DEVELOPMENT ASSESSMENT PANEL REPORT			
<b>Application No.</b>	DA/2023/0981		
<b>Address</b>	44 Waterview Street BALMAIN		
<b>Proposal</b>	Demolition of existing garage/storage structure and replacement with new garage and studio above, plus associated landscaping works and a new swimming pool		
<b>Date of Lodgement</b>	16 November 2023		
<b>Applicant</b>	Mrs Jana Mazzaferro		
<b>Owner</b>	Mrs Jana Mazzaferro and Mr Tommaso Mazzaferro		
<b>Number of Submissions</b>	Initial: 10; and After Renotification: 6 There are 11 unique submissions		
<b>Cost of works</b>	\$411,000.00		
<b>Reason for determination at Planning Panel</b>	Number of submissions		
<b>Main Issues</b>	<ul style="list-style-type: none"> <li>▪ View Loss</li> <li>▪ Bulk and Scale</li> </ul>		
<b>Recommendation</b>	Approved with Conditions		
<b>Attachment A</b>	Recommended conditions of consent		
<b>Attachment B</b>	Plans of proposed development

This report is an assessment of the application submitted to Council for the demolition of the existing garage/storage structure and its replacement with a new garage and studio above, plus associated landscaping works and a new swimming pool at 44 Waterview Street Balmain.

Image 1: North elevation with laneway envelope control in blue.

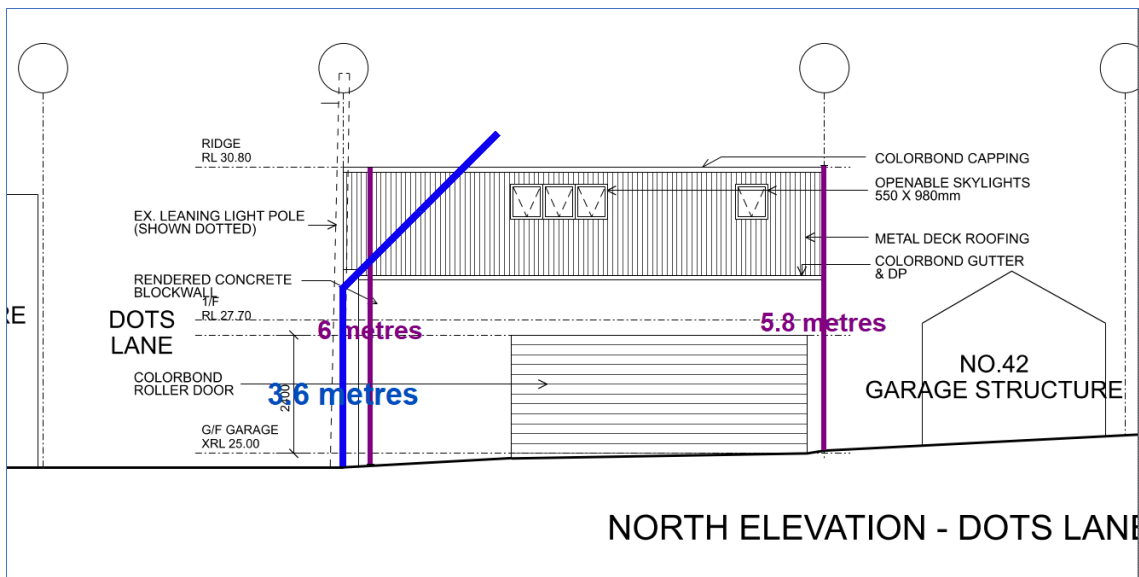
Dots Lane at the rear of the subject site is a Medium Lane with 6.09m width. The DCP does not specify which elevation the control applies to if the subject site is on a corner lot. The proposal when viewed from the northern elevation proposes a laneway envelope of 3.6m by 45degrees and a maximum roof height of 6m is required for any development fronting a Medium Laneway. A section of the proposed roof studio is outside the building envelope of 45degrees, see Image 1. However, when this is viewed from the east elevation, the proposal complies with the laneway control as above, see Image 1A below.

To reduce the non-compliance to the north elevation the conditions of consent will be imposed, which will also minimise any adverse amenity impacts on adjoining properties as discussed elsewhere in this report. The recommended conditions include the reduction of the garage roof to ceiling height to 2.2m in order to reduce roof ridge from RL30.80 to RL30.60. The eastern wall of the garage and studio proposed to be built on the boundary is to be setback 300mm from the eastern boundary. This will also result in a proposal with an envelope control taken from the east elevation which wholly complies with the controls prescribed in this part of the DCP.

Figure 10

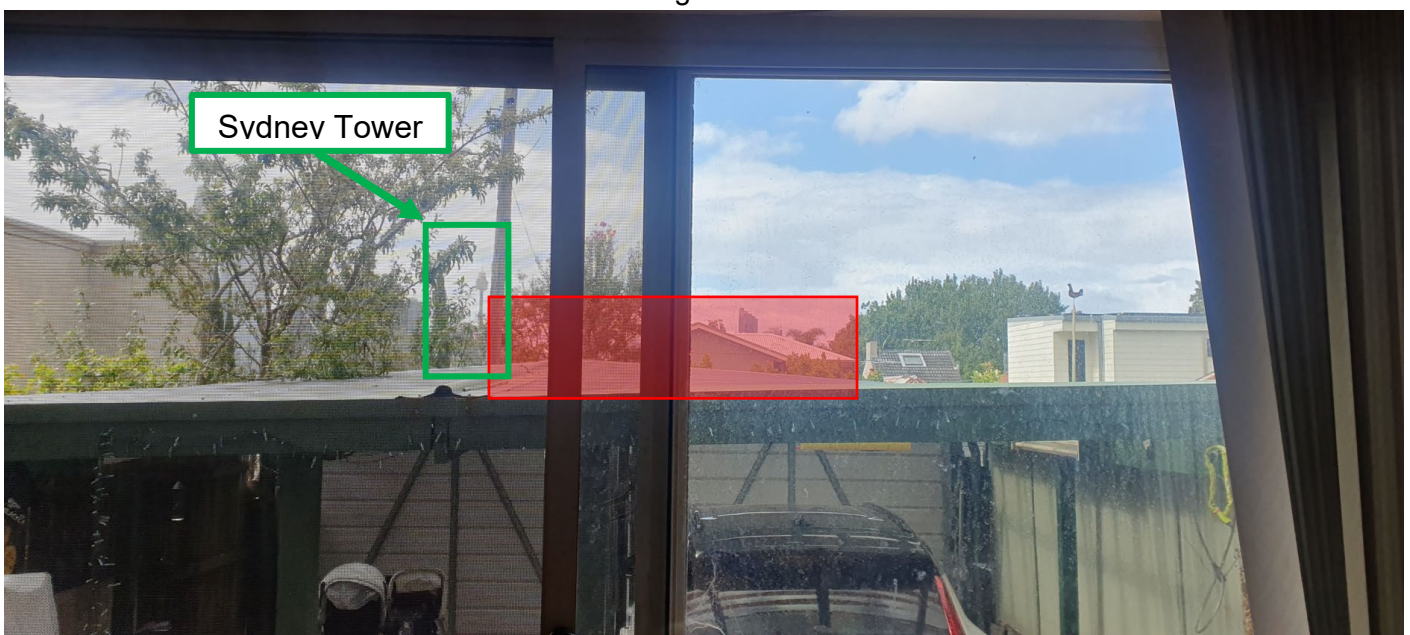
Figures 9 and 10 above demonstrates that view loss from the ground floor living area of No. 23 Campbell Street is largely negligible and clear views to the Sydney Tower in the background is retained.

Figure 24

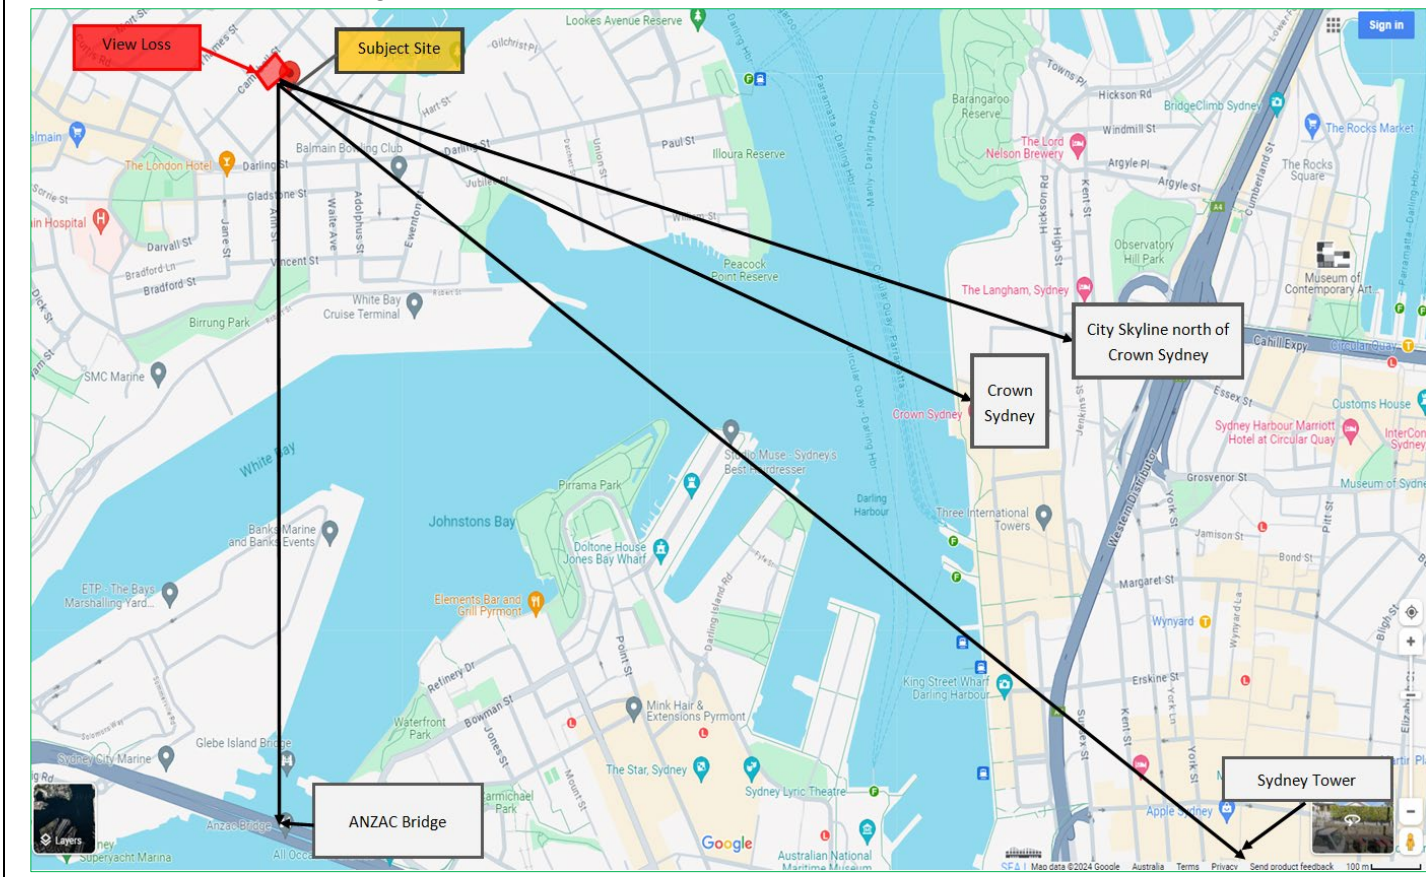
As demonstrated in Figures 17-24, the existing views enjoyed from a standing position by No. 25 Campbell Street from its first-floor bedroom is retained.
